SURVEYOR'S OFFICE

Re: Westfield Farms Drain – Western Way Road Improvements Reconstruction

**Re: Cool Creek – Westfield Farms Drain: Western Way Rd Improvements Reconstruction**

PLAN AND PROFILE  
 WESTERN WAY  
 LINE "C"

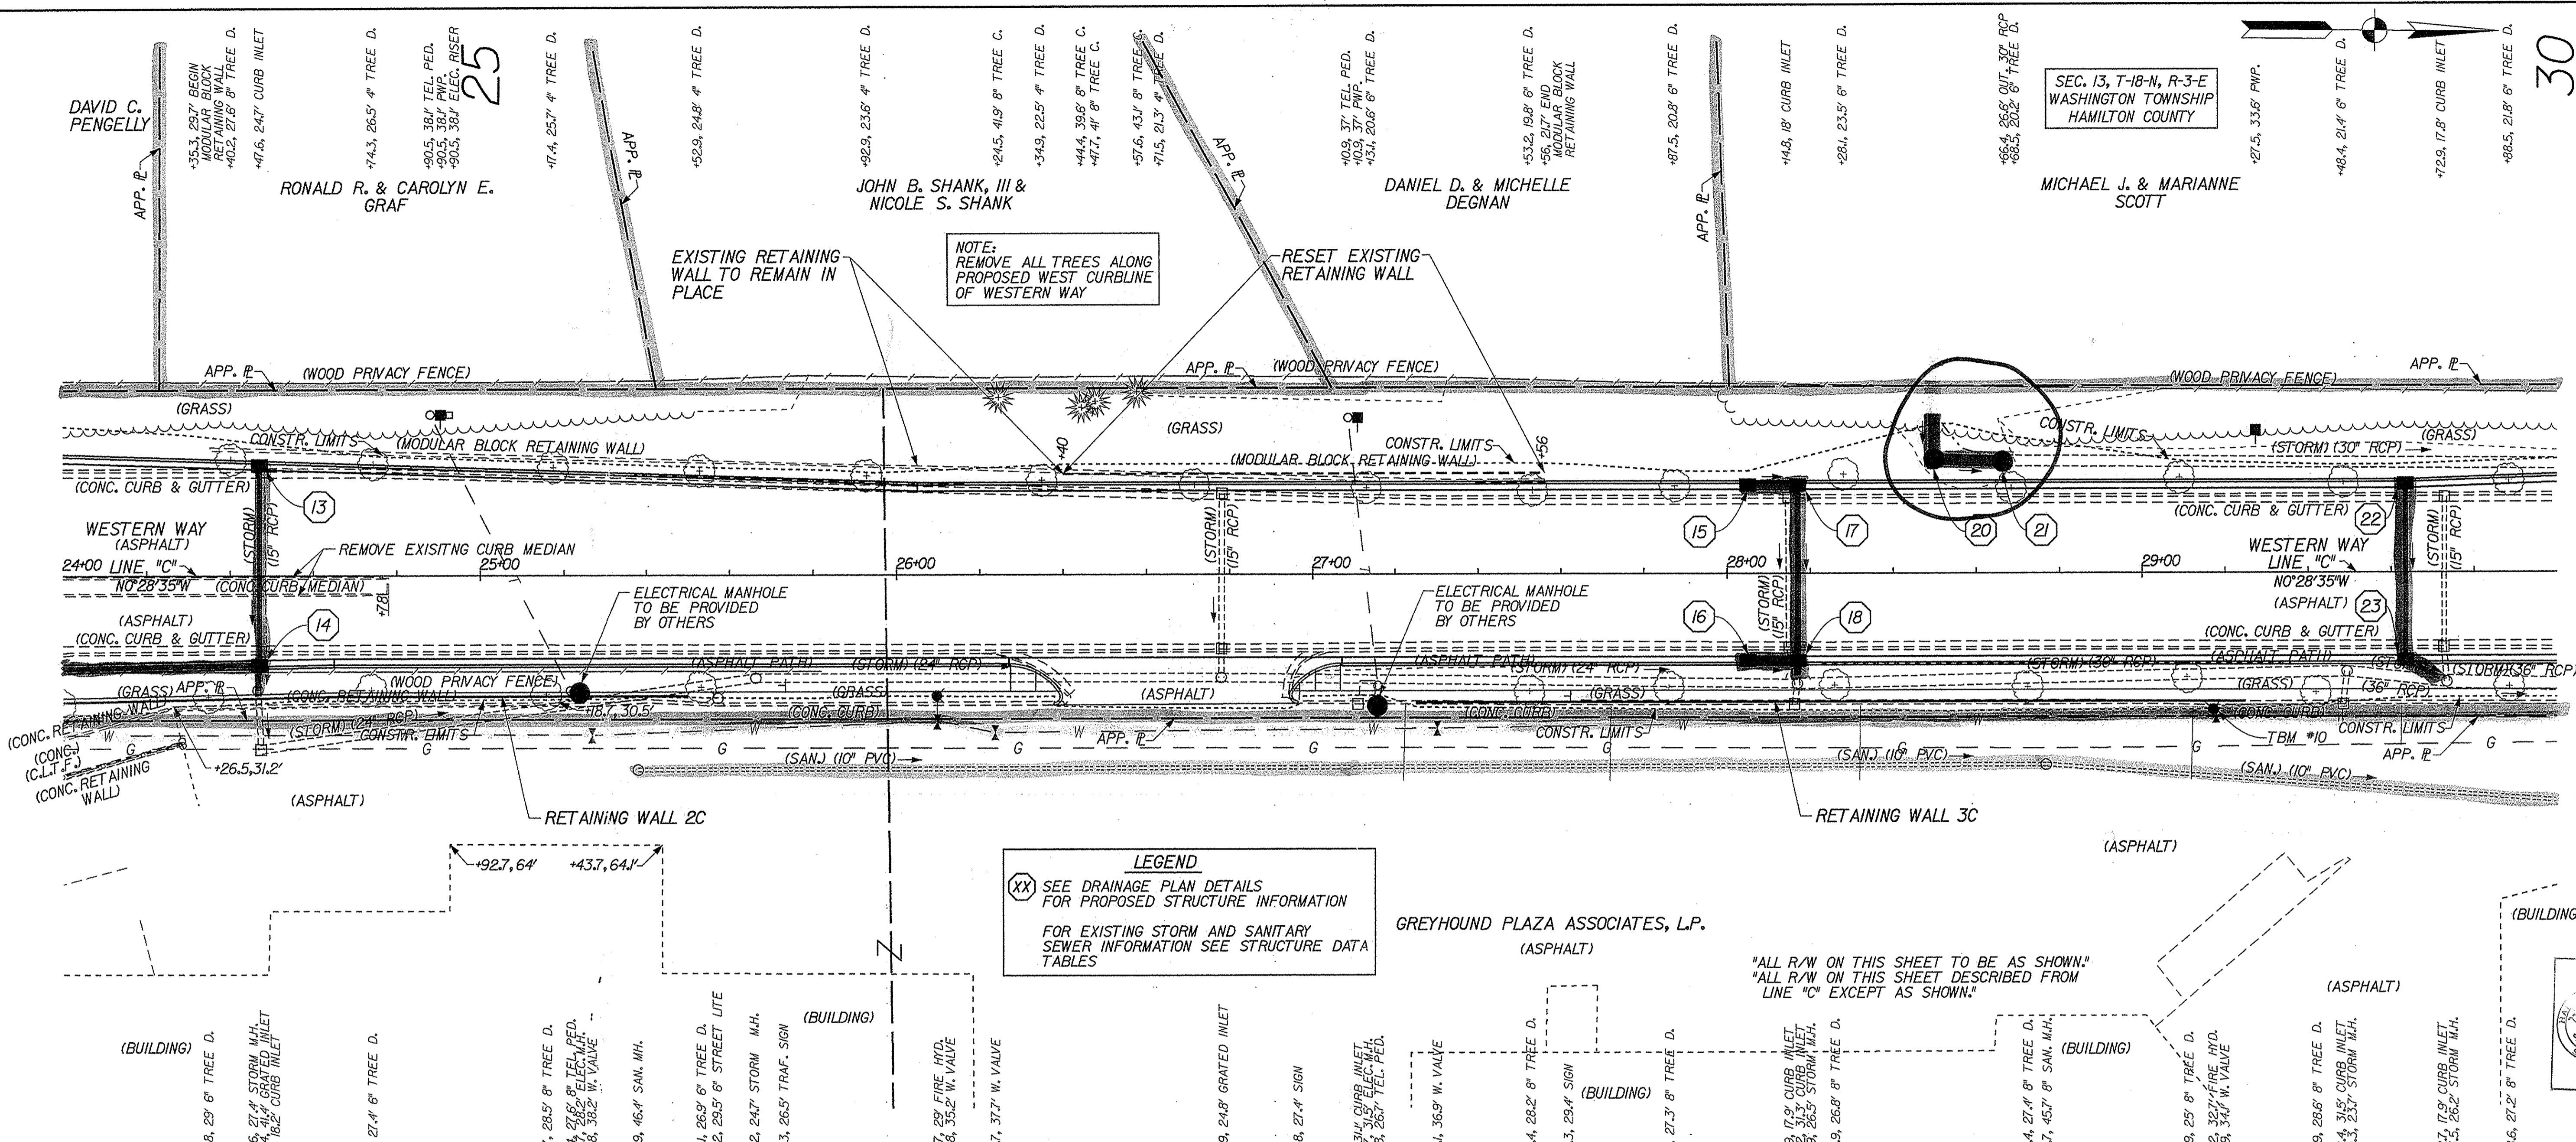
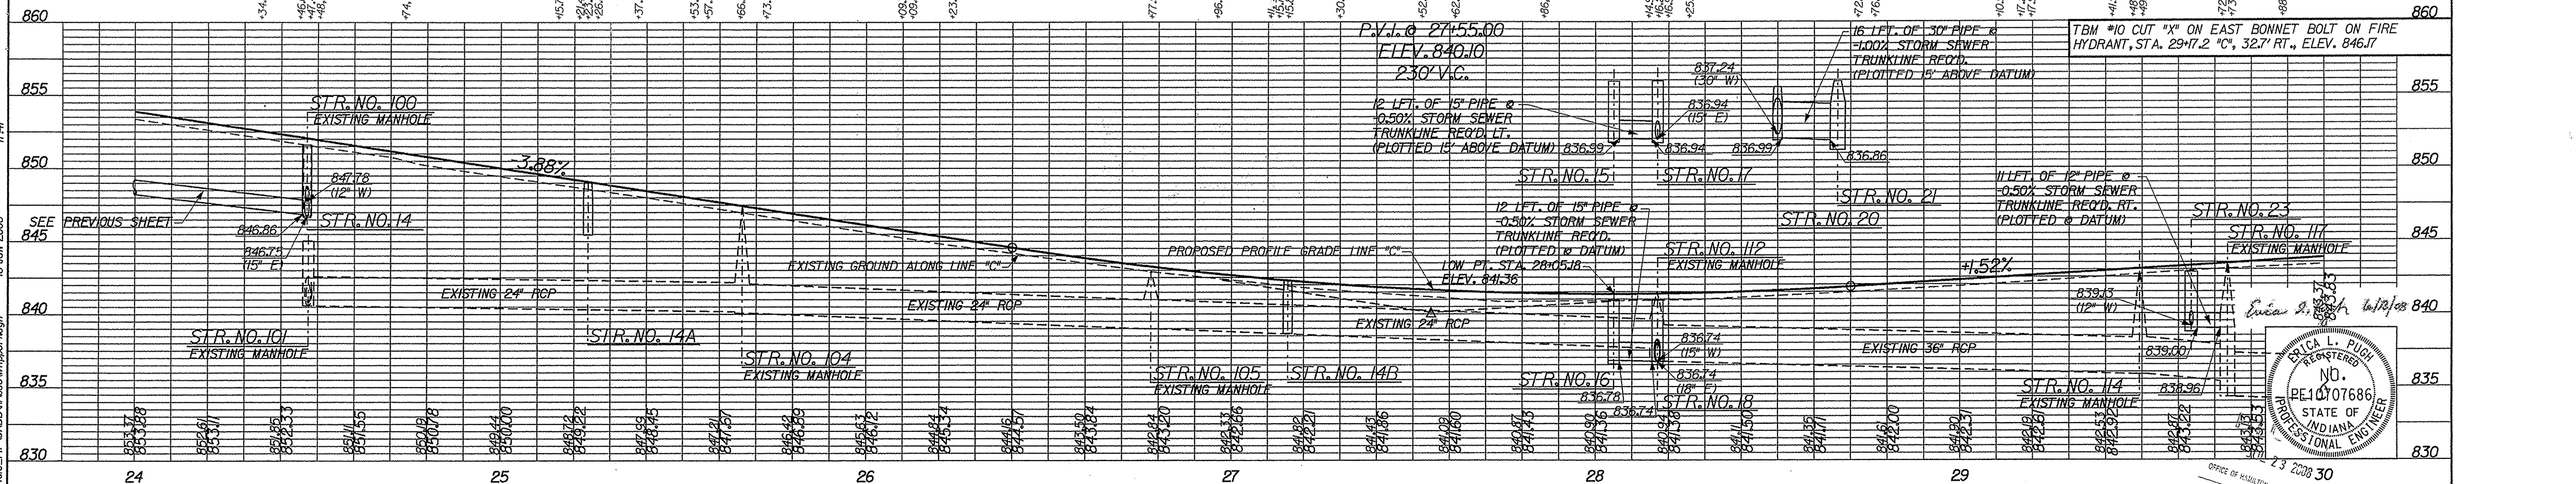
During construction, changes were made to the drain, which will alter the plans submitted with my report for this drain-dated June 5, 2009. The report was approved by the Board at the hearing held June 22, 2009. (See Drainage Board Minutes Book 12, Pages 93-94)

The 30" RCP was lengthened from 16 feet to 36 feet drain. The length of the drain due to the changes described above is now **36 feet**. There was also 15 feet of open ditch that was removed along with two end sections (Str. 43 & Str. 2). Therefore, this project added 21 feet of drain to the watershed's overall length.
